SERVICE BULLETIN

FUJI HEAVY INDUSTRIES LTD.

NO : FAS - 073

1. SUBJECT : Inspection of Fuel Tank Vent Line and Addition of Clamps.
2. AIRCRAFT AFFECTED : FA-200 Series Aircraft S/N 1 thru 263.
3. PRIORITY : Essential.
4. REASON : To perform special inspection of the subject vent line and install attaching clamps, since there have been several cases reported whereby cracks have occurred in the vent line root end attached to the fuel tank.
5. DESCRIPTION : Visually inspect the tube root end for cracks, and, if no cracks are found, install three AN742D4 clamps. If any crack is detected, notify Fuji Heavy industries, Ltd.
6. ACCOMPLISHMENT : At the next 50 hour inspection or 100 hour inspection, whichever will occur first.
7. APPROVAL : JCAB Approval (NO-TOKYO-099) December 27, 1974.
8. PARTS REQUIRED : The following parts are required to perform this modification :

FIGURE 1

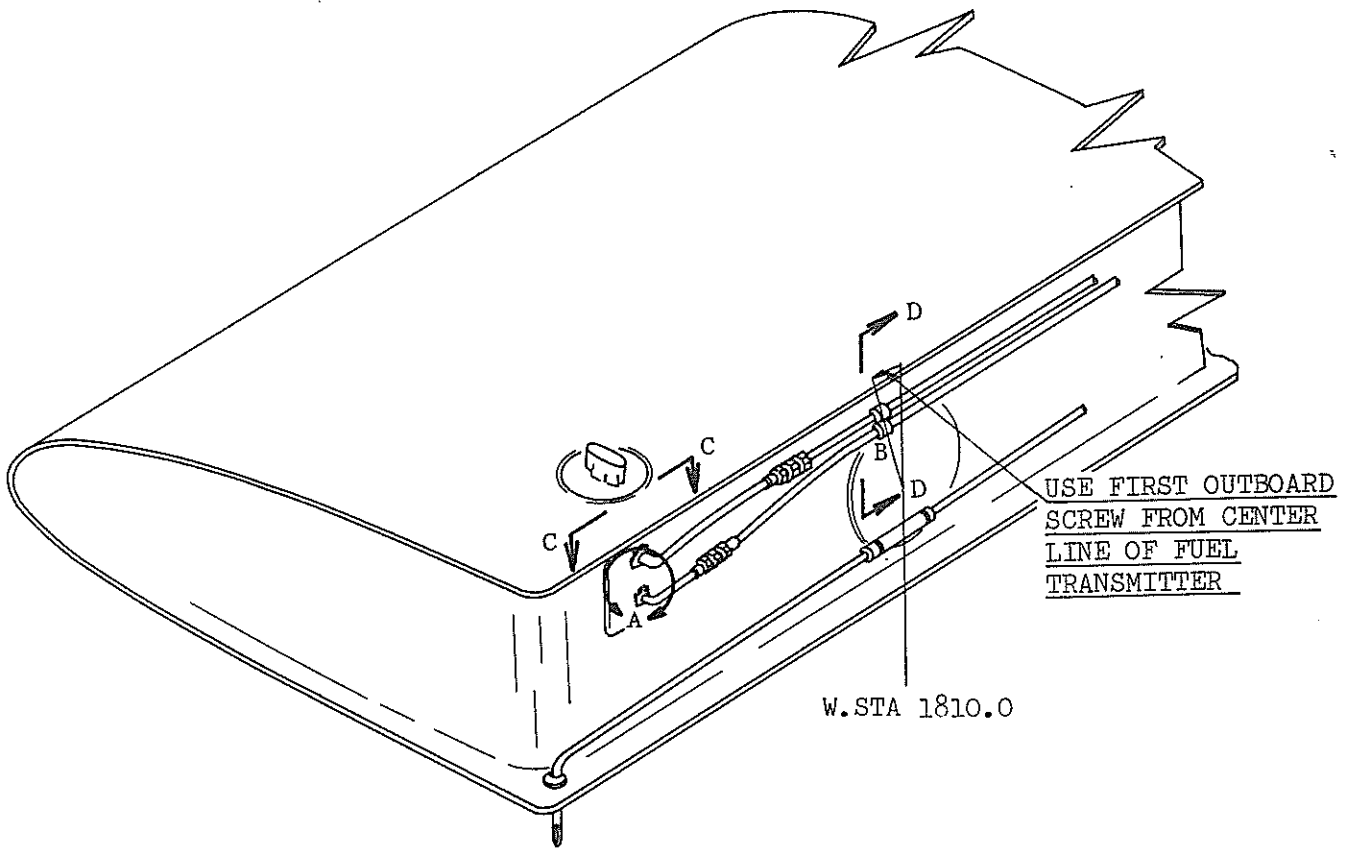
11. REFERENCE : Not applicable.
12. MANHOUR REQUIRED : 8.0 manhours required.
13. DETAILED INSTRUCTIONS :
- (1) Position aircraft in a safe area and drain fuel.
 - (2) Remove fuel tank in accordance with Service Manual, para 6-3-1.
 - (3) The fuel tank vent line should be visually inspected with particular attention given to the specific area of the tube. (Ref. Figure 1, area A). If no damage is found, proceed with the following steps (4) thru (9). If any crack is found, notify Fuji Heavy Industries, Ltd.
 - (4) Remove lockwire and remove one of the bolts attaching fuel quantity transmitter (See Figure 1, area B).
 - (5) Install clip AN743-13 with the bolt removed in the above step 4.
 - (6) Tighten bolt to 45 to 55 in-lb and secure with lockwire.
 - (7) L.H Fuel Tank :

Secure two vent tubes to clip with two clamps AN742D4, one screw MS35206-245 and one nut NAS679A08W.
 - (8) R.H Fuel Tank :

Secure one vent tube to clip with one clamp AN742D4, one screw MS35206-245 and one nut NAS679A08W.
 - (9) Reinstall fuel tank in accordance with Service Manual, para 6-3-3.

CLAMP	AN742D4	2 REQD
CLIP	AN743-13	1 REQD
SCREW	MS35206-245	1 REQD
NUT	NAS679A08W	1 REQD

CLAMP	AN742D4	1 REQD
CLIP	AN743-13	1 REQD
SCREW	MS35206-245	1 REQD
NUT	NAS679A08W	1 REQD
